**Rock Hill Schools
Rock Hill, South Carolina
STMS Cabling Upgrades
RFP # 22-2325 RHSD**

Addendum One – March 3rd, 2023

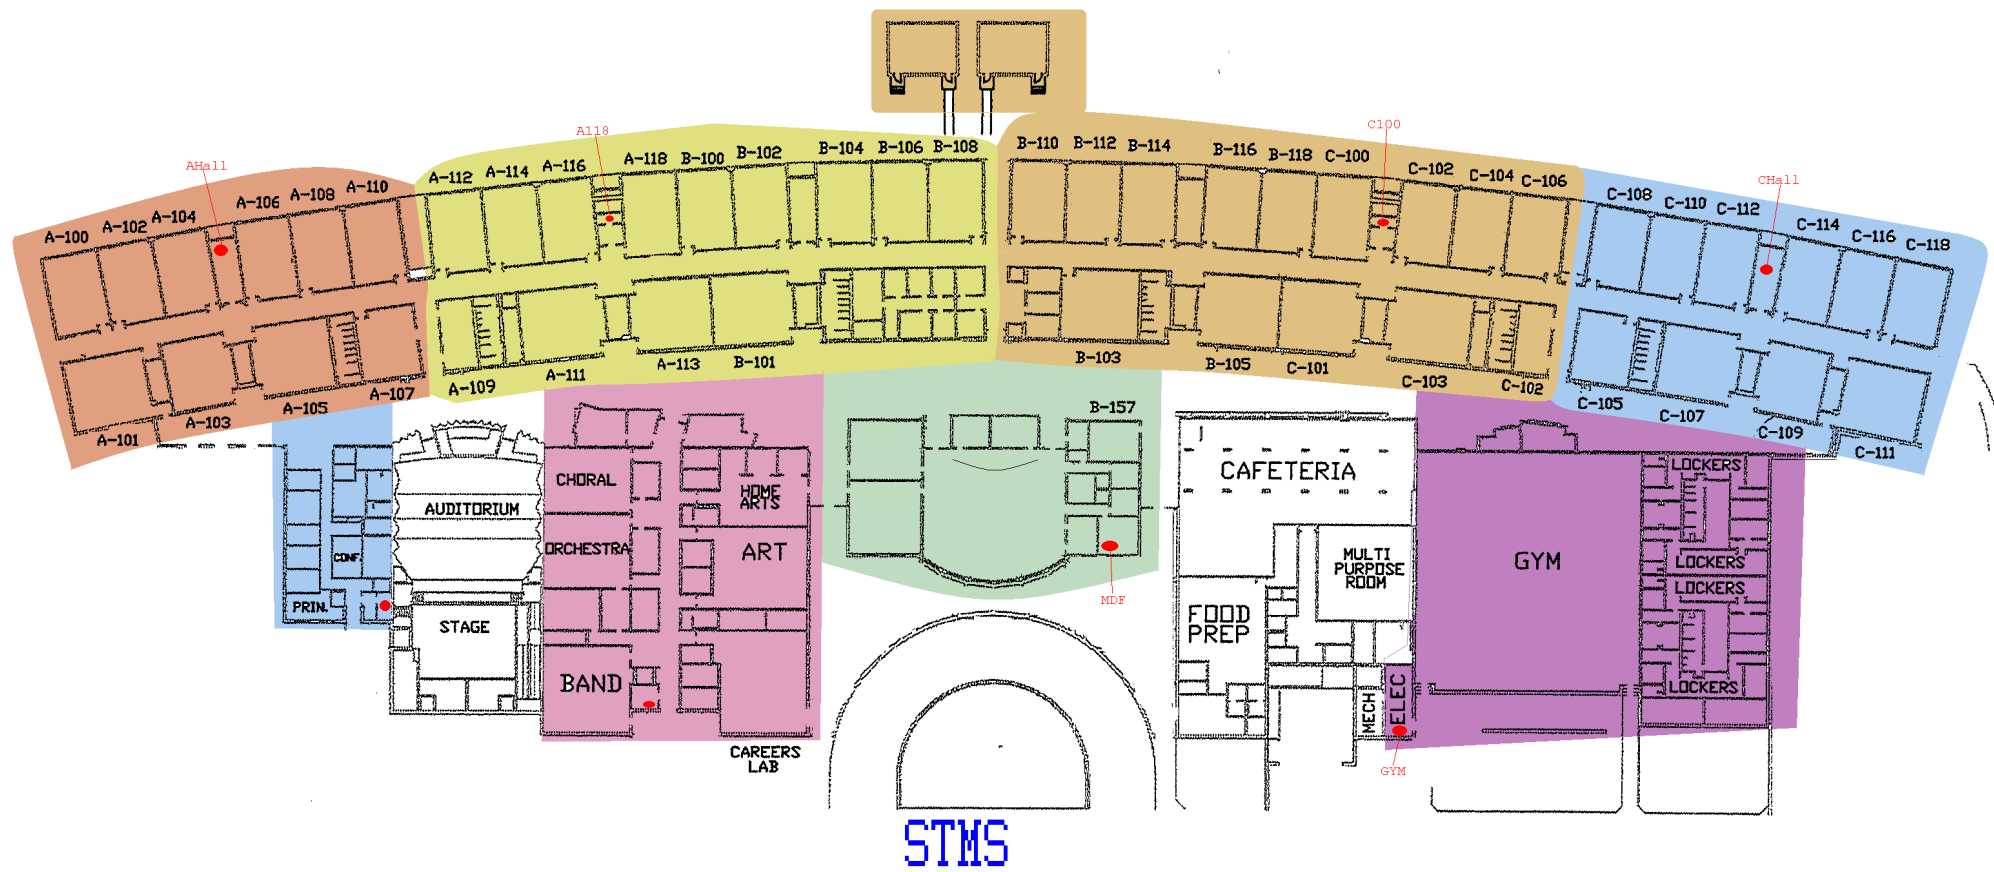
N10: What length patch cables for closet and user end?

N10 Response: The District uses the shortest possible closet patch cables with the maximum cable lengths being 5ft. User-end cables are a maximum of 10ft. Vendors should not quote for any patch cabling however.
